DOCUMENT 00 90 00
ADDENDUM

ADDENDUM NO. [3] Date: November 7, 2018

**RE: PRENTICE SCHOOL DISTRICT
 ADDITION AND REMODELING BID PKG 3
 1025 TOWN ST
 PRENTICE, WI 54556
 HSR PROJECT NO. 18022**

S002R

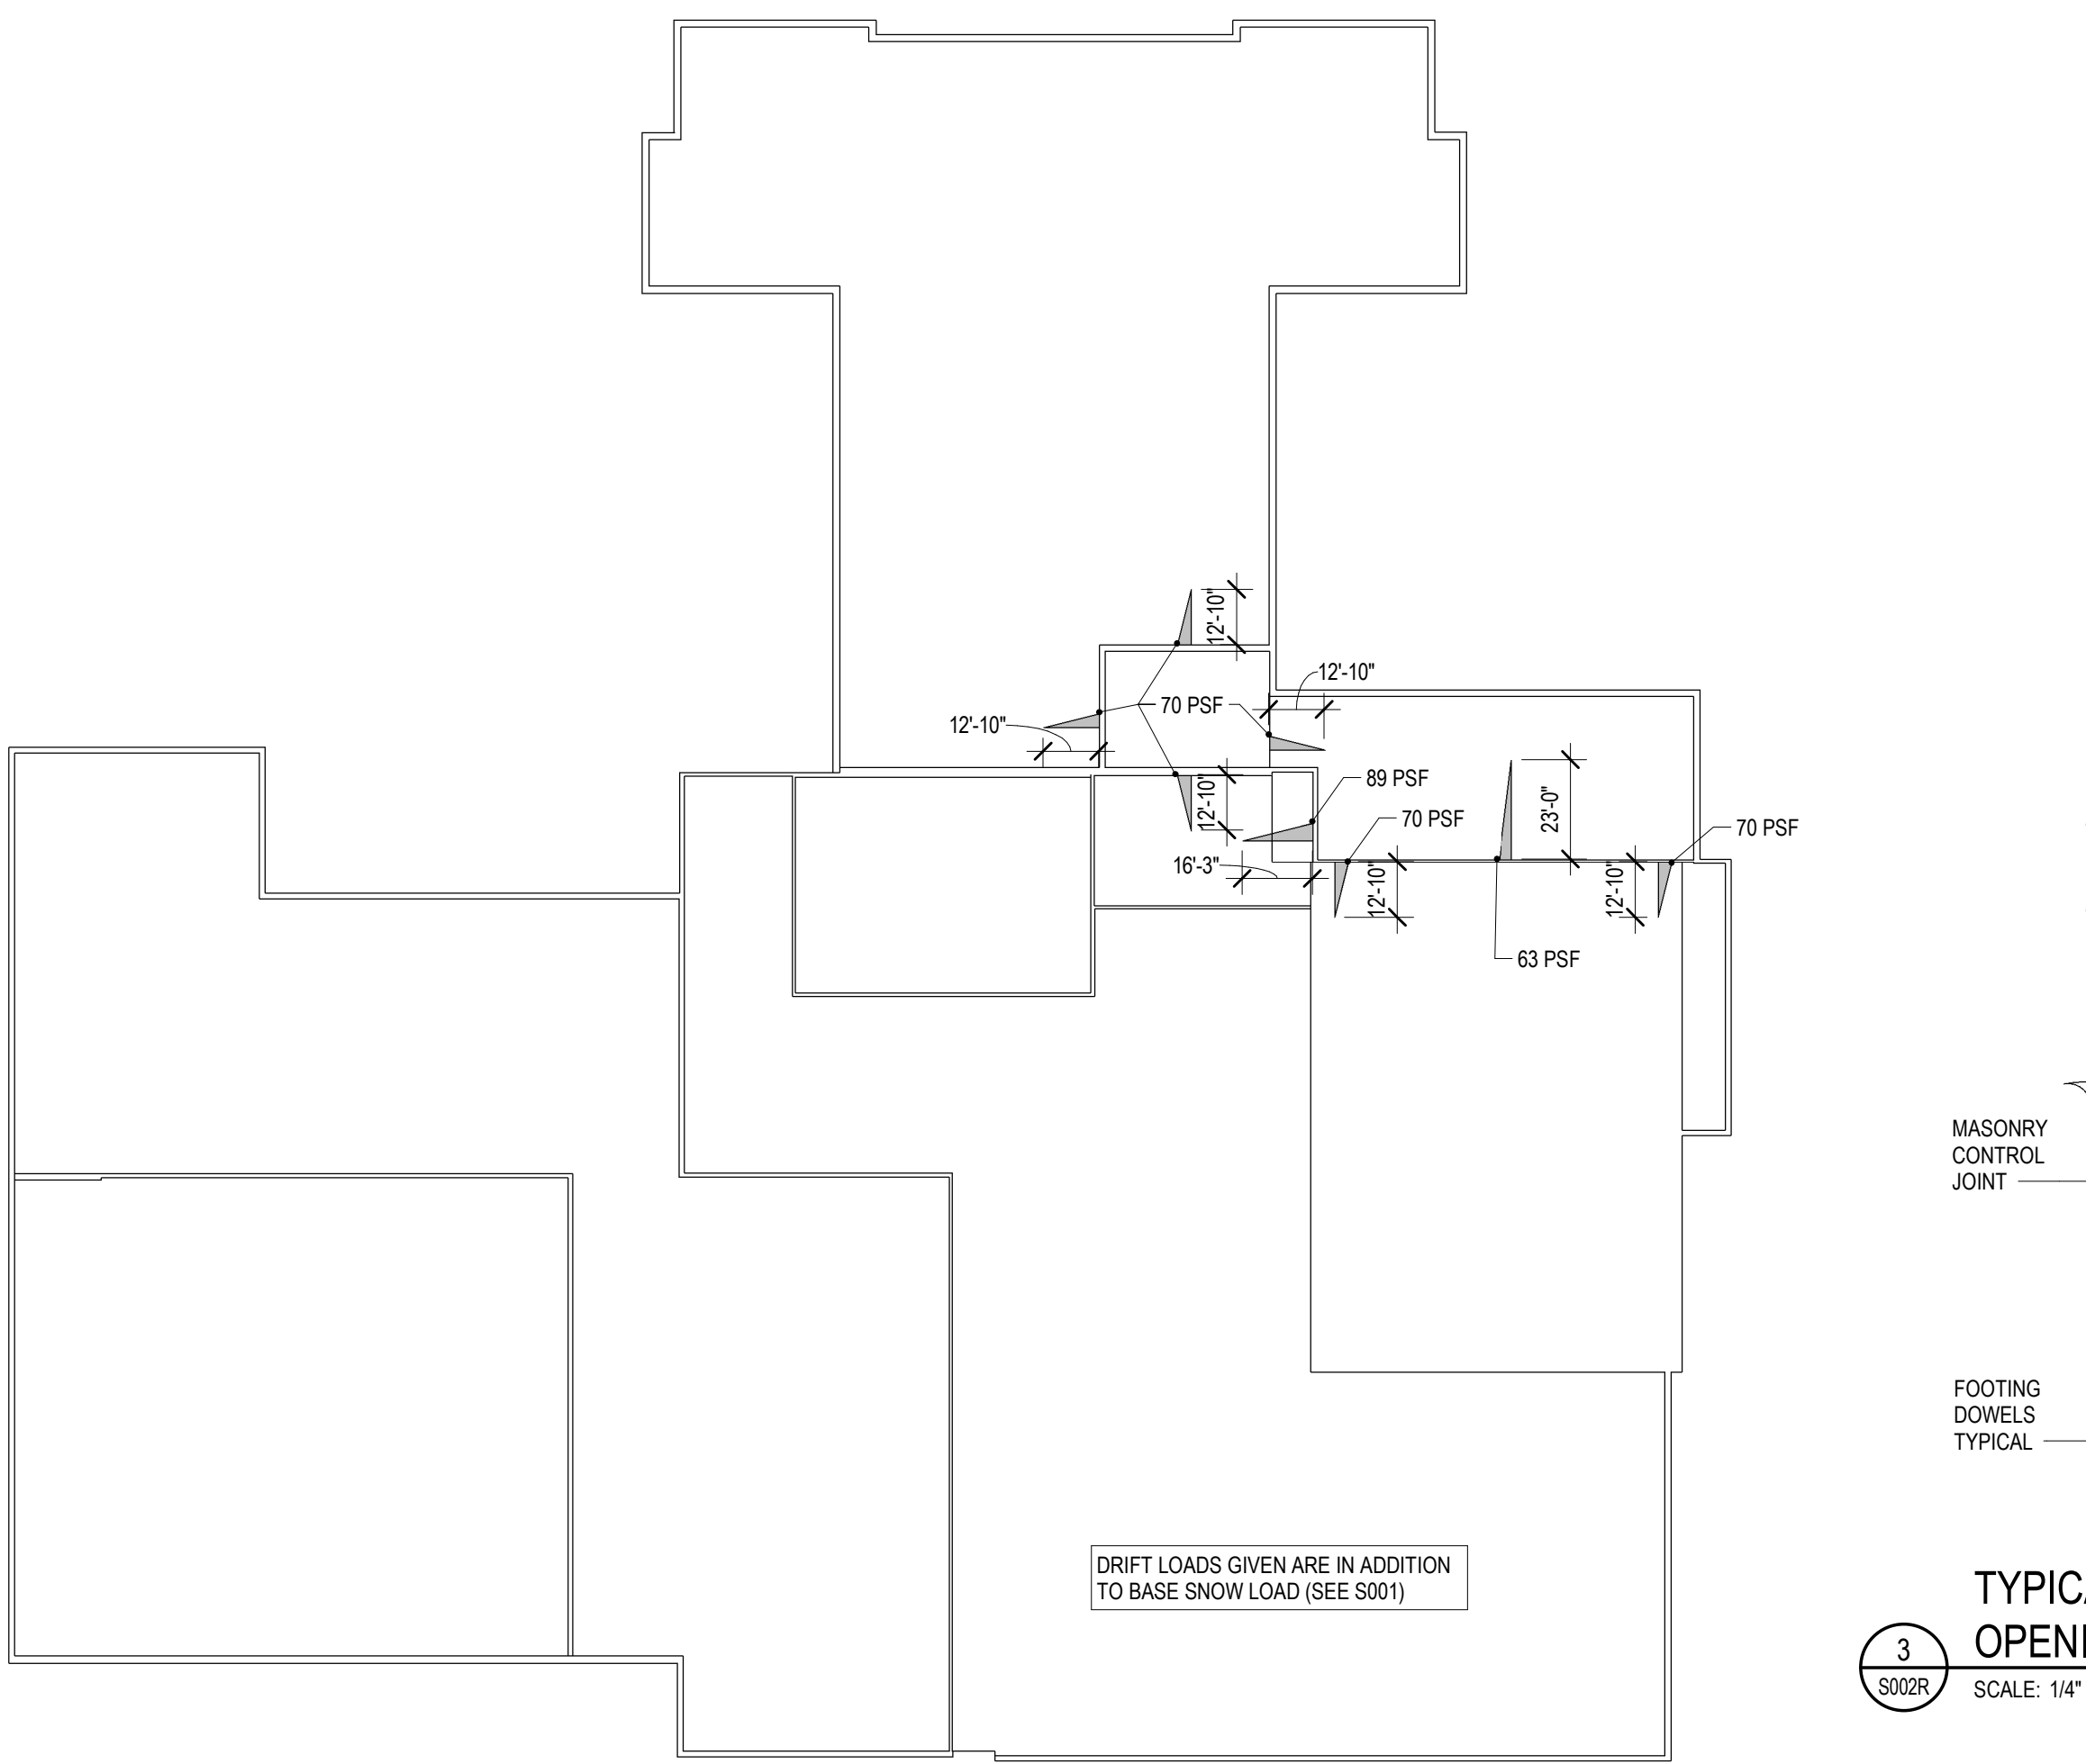
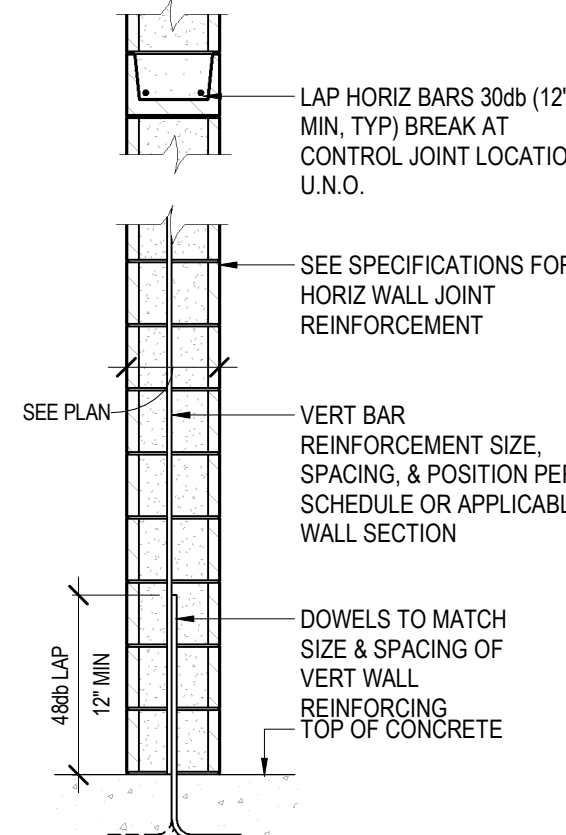
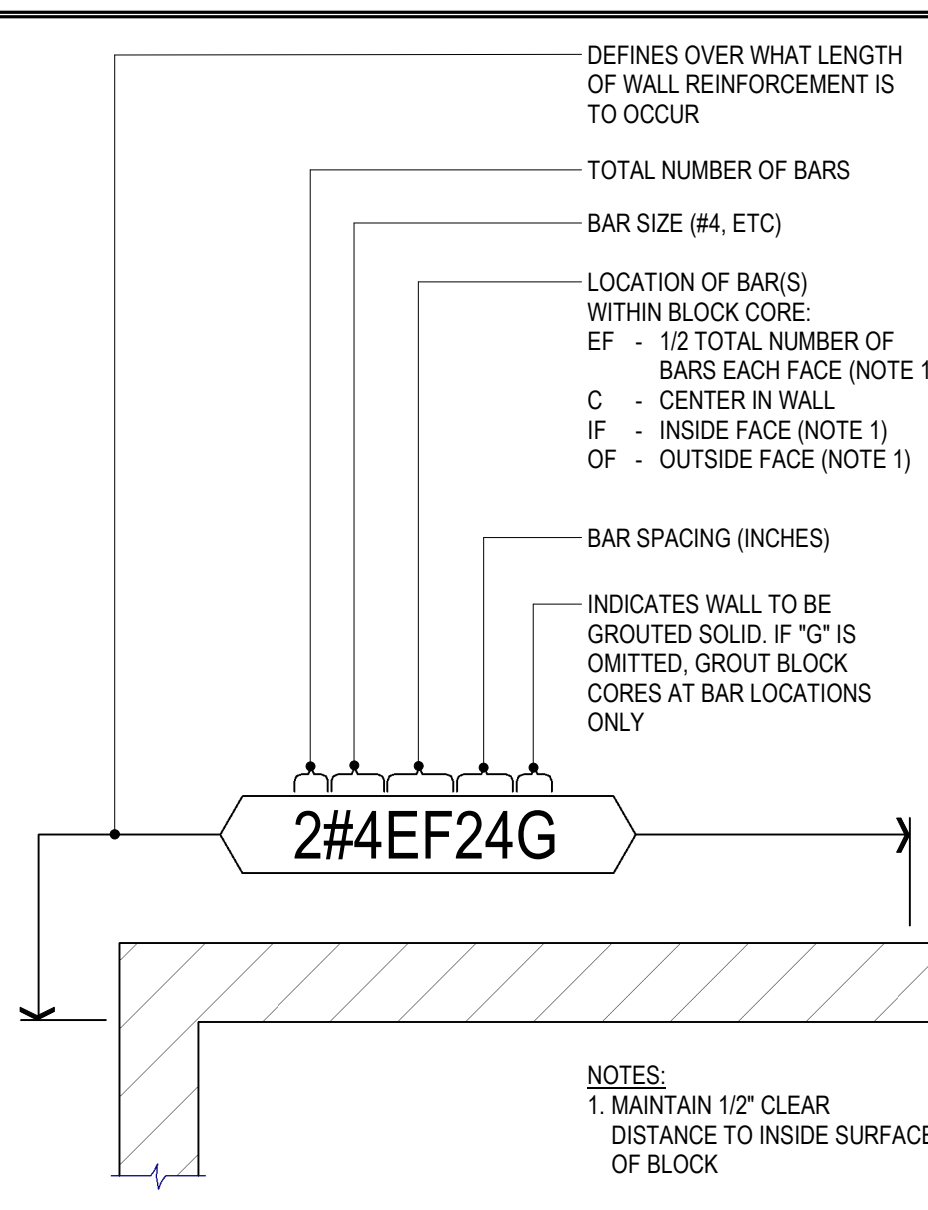
- a. Revisions clouded on Drawing.
 - b. Revised extents of brick at west wall
3. Sheet S002R STRUCTURAL SCHEDULES 30 x 42 attached hereto.
 - a. Revisions clouded on Drawing.

- b. Revision to miscellaneous lintel schedule to provide steel options for new openings in existing walls.
4. Sheet S200R ROOF AND PENTHOUSE FLOOR FRAMING – SEGMENT C 30 x 42 attached hereto

S200R

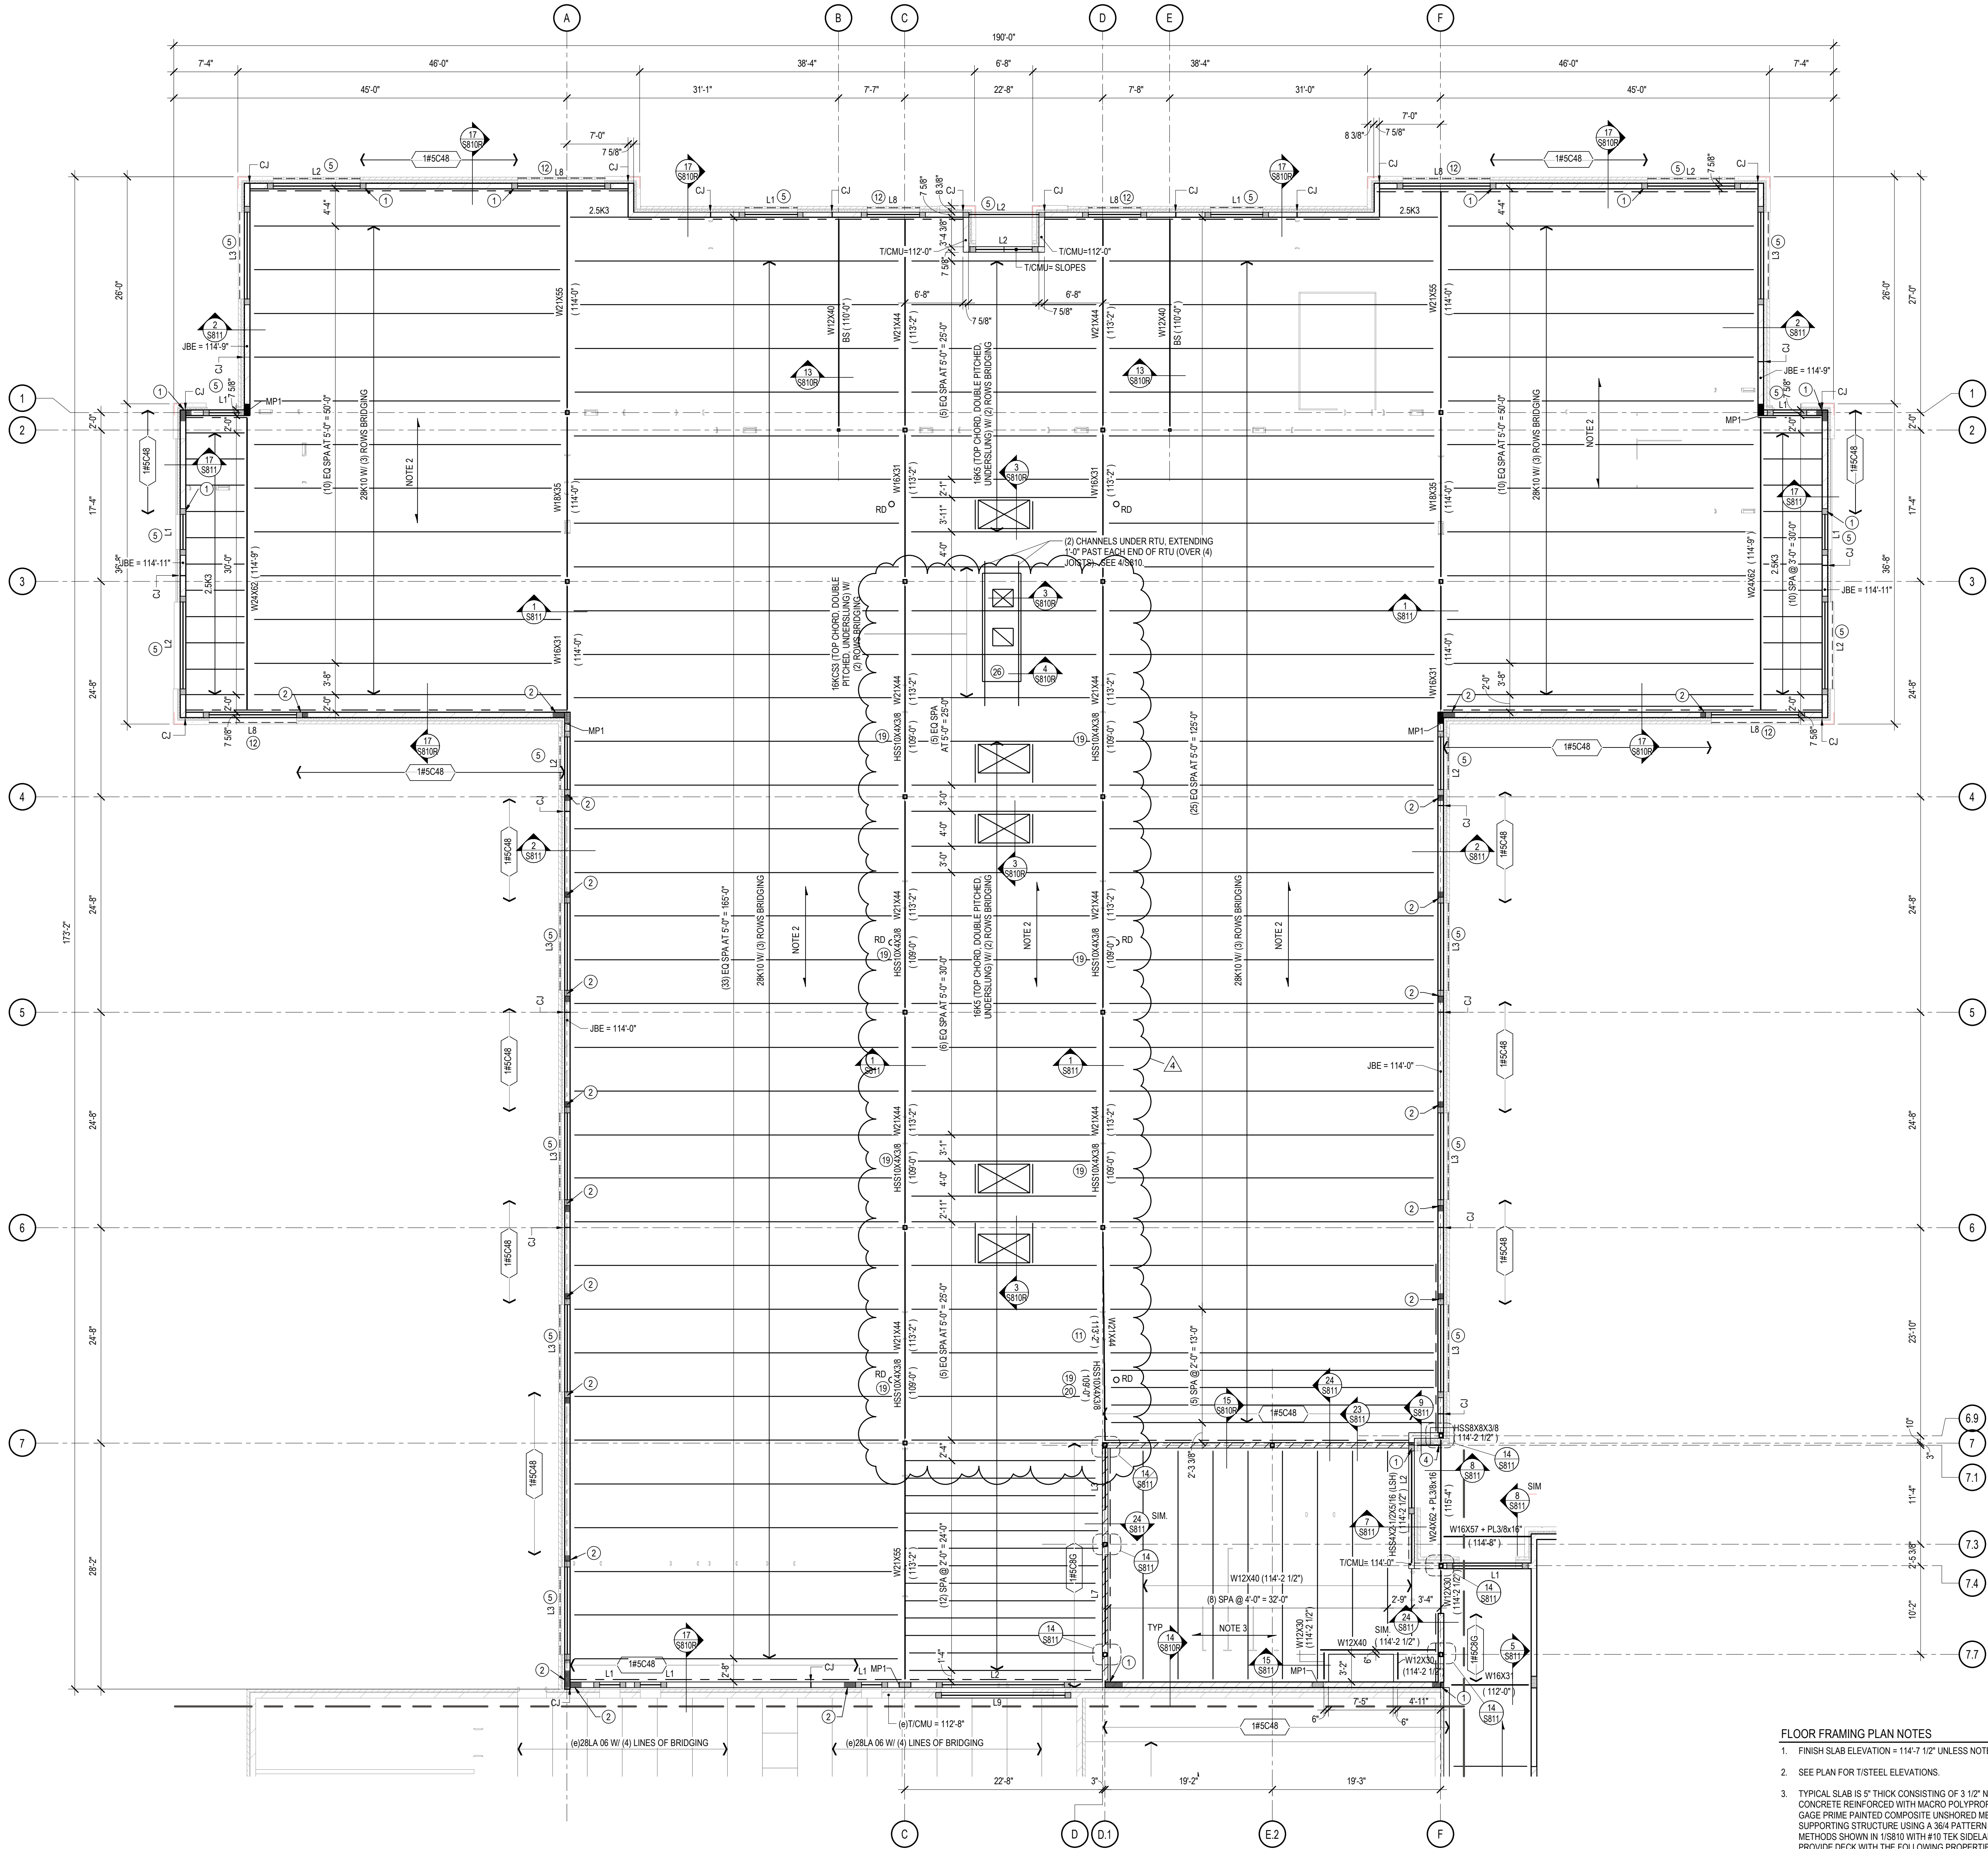
- a. Revisions clouded on Drawing.
 - b. Added framing to support sliding glass door systems along grids C and D. Added keynotes to include RTU information.
